Access Compliance Report

Public Rights-of-Way

(Pedestrian Signals)

Intersection ID: N/A	Main Street:	Cross Street: N/A	Location: N/A
ADA ID: C3C25A14DF91	Signal Type: Two Push Buttons-APS	Overall Compliance: No	Severity Score: BTN 1:N/A BTN 2: N/A No BTN: N/A
Codes/Mitigation Info/Possible Solution		Field Measurements/Component Compliance

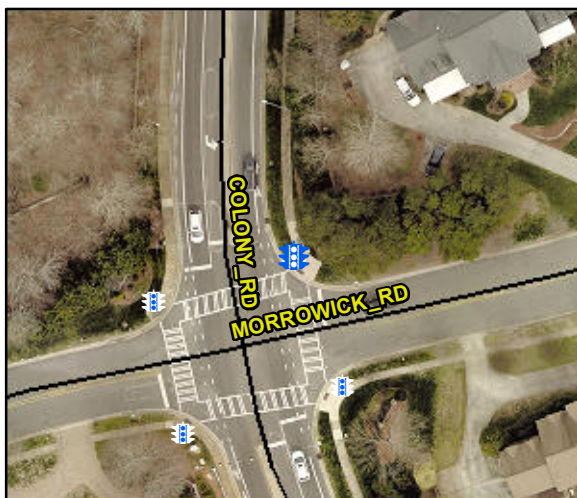
PROW/ADA: TMUTCD 4e.08, R404.2, R406.2, , R404.3

Compliance	Description	Data	Compliance	Description	Data
	Button Count	Button2	N/A	Distant to Additional Button (in)	N/A
	Additional Button Present?	No		Additional Button ID	N/A
N/A	Signal Buttons Required?	N/A	N/A	Additional Ped Posts Required	N/A
	How Many Ped Street Xings?	2		Located In An Island/Median?	No
N/A	B 1 Sign Present?	Yes	N/A	B 2 Sign Present?	Yes
Yes	B 1 Sign Purpose?	Yes	Yes	B 2 Sign Purpose?	Yes
Yes	B 1 Sign Lettering & Contrast?	Yes	Yes	B 2 Sign Lettering & Contrast?	Yes
Yes	B 1 Parallel To XWalk?	Yes	Yes	B 2 Parallel To XWalk?	Yes
Yes	B 1 PAR to Button?	Yes	Yes	B 2 PAR to Button?	Yes
Yes	B 1 PAR to XWalk?	Yes	Yes	B 2 PAR to XWalk?	Yes
Yes	B 1 Clear Floor Space?	Yes	Yes	B 2 Clear Floor Space?	Yes
N/A	B 1 FWD Approach?	Yes	N/A	B 2 FWD Approach?	Yes
N/A	B 1 FWD Approach Constrained?	No	N/A	B 2 FWD Approach Constrained?	No
No	B 1 FWD Approach Reach (in)	8.0	No	B 2 FWD Approach Reach (in)	8.0

N/A	B 1 FWD Approach Width (in)	N/A	N/A	B 2 FWD Approach Width (in)	N/A
N/A	B 1 FWD Approach Obstruction?	Yes	N/A	B 2 FWD Approach Obstruction?	Yes
N/A	B 1 FWD Approach Obstruction Dist (in)	2.0	N/A	B 2 FWD Approach ObstructionDist (in)	2.0
N/A	B 1 PARA Approach?	Yes	N/A	B 2 PARA Approach?	Yes
N/A	B 1 PARA Approach Constrained?	No	N/A	B 2 PARA Approach Constrained?	No
Yes	B 1 PARA Approach Reach (in)	8.0	Yes	B 2 PARA Approach Reach (in)	8.0
N/A	B 1 PARA Approach Width (in)	N/A	N/A	B 2 PARA Approach Width (in)	N/A
N/A	B 1 PARA Approach Obstruction?	Yes	N/A	B 2 PARA Approach Obstruction?	Yes
N/A	B 1 PARA Approach Obstruction Dist (in)	2.0	N/A	B 2 PARA Approach ObstructionDist (in)	2.0
Yes	B 1 Clear Floor Space Slope (%)	2.4	No	B 2 Clear Floor Space Slope (%)	12.5
No	B 1 Clear Floor Space XSlope (%)	14.9	No	B 2 Clear Floor Space XSlope (%)	5.4
N/A	B 1 PAR Slope (%)	2.7	N/A	B 2 PAR Slope (%)	7.7
Yes	B 1 Height (in)	35.5	Yes	B 2 Height (in)	35.0

Yes	B 1 Clear Xing Direction?	ClearlyMarked	Yes	B 2 Clear Xing Direction?	ClearlyMarked
	B 1 Crossing Direction	To SW		B 2 Crossing Direction	To SE
No	B 1 DistanceTo XWalk (in)	63.0	Yes	B 2 DistanceTo XWalk (in)	0.0
No	B 1 DistanceTo Curb (in)	74.0	No	B 2 DistanceTo Curb (in)	78.0
Yes	B 1 Diameter (in)	2.0	Yes	B 2 Diameter (in)	2.0

Possible Solutions: Replace Signal Push Button With APS Button on New Post. Remove & Relocate Sign.
